Planning Applications Manager
Leek Councils Connect
Moorlands House
Stockwell St
Leek,
ST13 6HQ
planning@staffsmoorlands.gov.uk

Letter of objection - SMD/2016/0430 – Land off Uttoxeter Rd, Lower Tean

a) Statement on the validity of the planning map from Staffs Moorlands District Council.

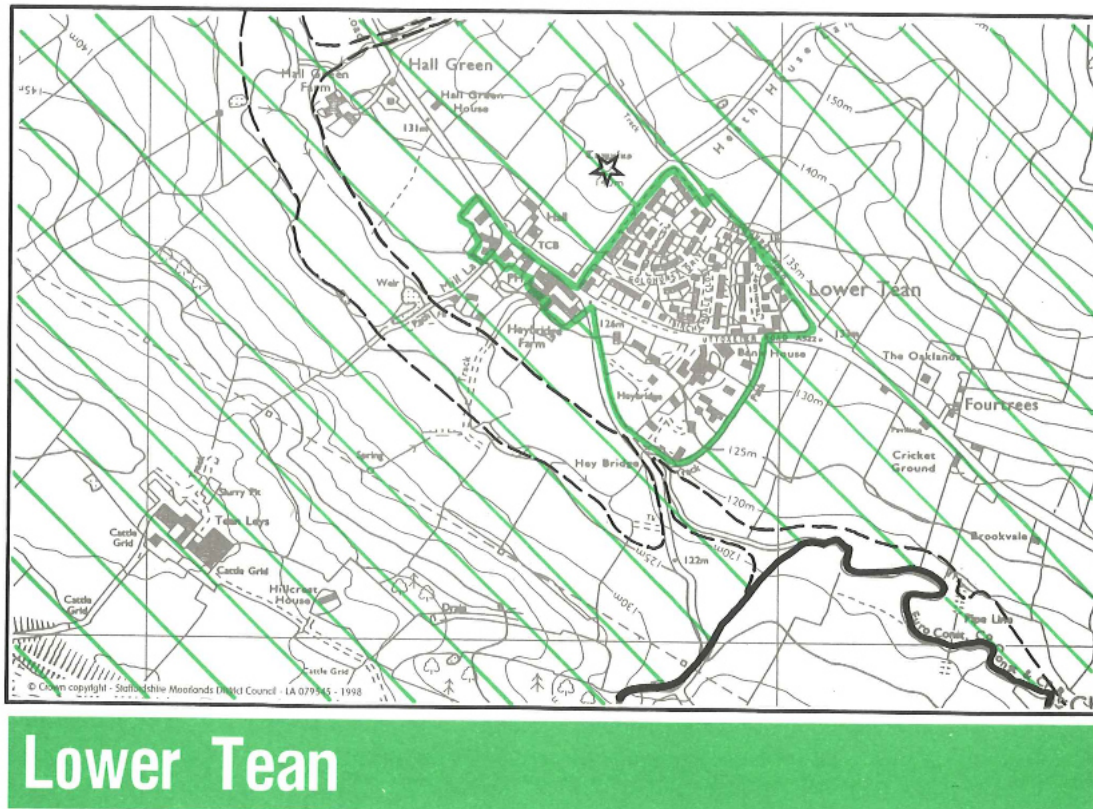
- The current SMDC site allocation plan says that plot LT001 is outside the Development Area and should not be built on.
- The site is in a “Special Landscape Area” and that designation is still in force
- SMDC documents state very clearly that the *existing development map applies* until the present review is complete.
- It is very clear that the existing map applies and that the proposal is outside the permitted boundary.
